Accredited Standards Committee  
X3, Information Processing Systems

Doc: X3T10.1/96a113r0  
Date: February 1, 1996  
Project: X3T10.1 / 1147  
Ref Doc.: SSA-TL2  
Reply to: John Scheible

Subject: Simple speed negotiation proposal

**Figure 1 - Time diagram of two out of sync ports during speed negotiation**

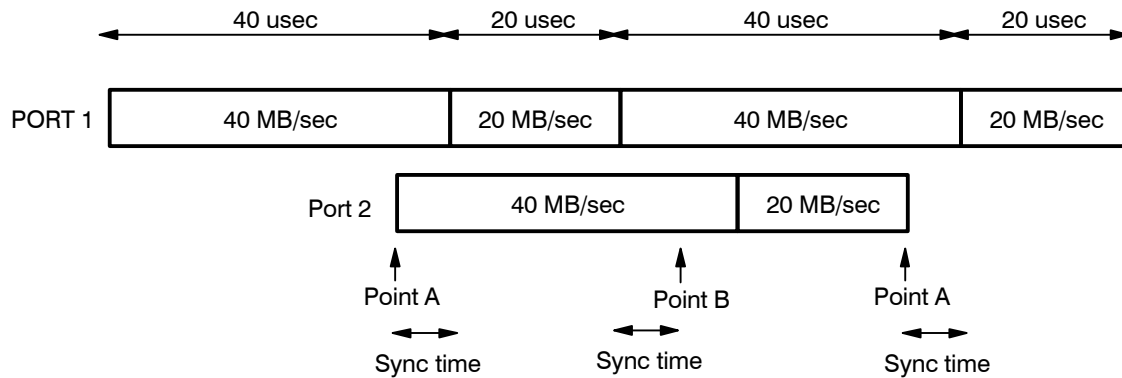
The 20 MB/sec case runs at the twice the maximum synchronization time of 200 characters (400 characters). The 40 MB/sec case runs twice as long (real-time) as the 20 MB/sec case (1600 characters) causing the condition shown in Figure 1. If Port 2 begins speed negotiation after port 1 but before point A, then synchronization occurs at 40 MB/sec. If Port 2 begins speed negotiation at point A, the synchronization occurs at 40 MB/sec at point B. If Port 2 begins speed negotiation after Point B but before point A, then synchronization occurs at 40 MB/sec.
